***Urgent Field Safety Notice for:  
Dako Autostainer Instruments (AS480; AS100; S3800; S3400):***

**Update of Autostainer Link Basic User Guide to reduce risks of staining issues due to leakage**

#### “Instrument leakage inspection

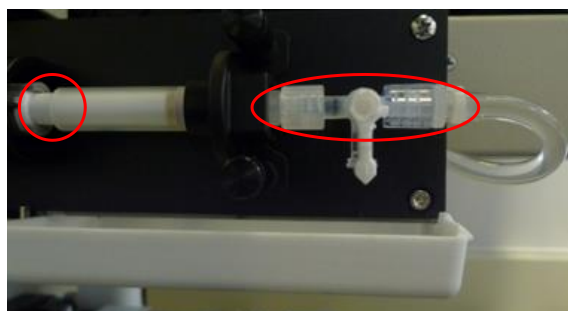
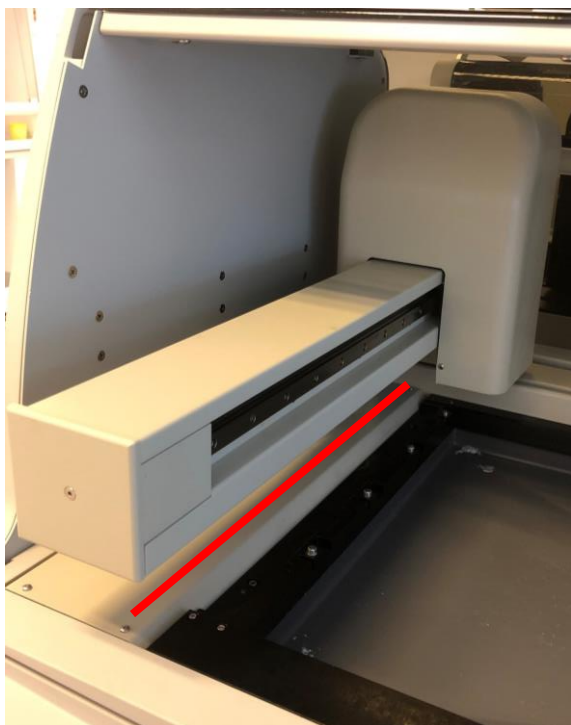
- **New section below has been added regarding inspecting the instrument for signs of leakage** (Table in “Cleaning and Maintenance Guideline Summary”, in English version: page 182, and in subsection “Instrument Leakage Inspection”, start of subsection in English version: page 188)

Visually Inspect the left plate, and the area around the wash station for salt residues and/or liquid, see pictures below. If there are signs of unexpected salt residues and/or liquid, contact your local Agilent Technical Service representative as this might indicate a leakage in the liquid system. If leakage is observed, the slides from the run just completed must be closely reviewed for staining abnormalities.”

**WARNING** Leakage from the robotic arm or z-head may impact staining quality. Do not use the instrument if there are signs of unexpected leakage (salt residues and/or liquid), or if you observe leakage.

Visually inspect the syringe tray, syringe and stopcock, areas highlighted in red, for signs of unexpected leakage (salt residues and/or liquid).

Visually inspect the left plate, area highlighted in red, for signs of unexpected leakage (salt residues and/or liquid). This might indicate leakage from the robotic arm.

Visually inspect the area around the wash station, area highlighted in red, for signs of unexpected leakage (salt residues and/or liquid). This might indicate leakage from the z-head or too high pump pressure.
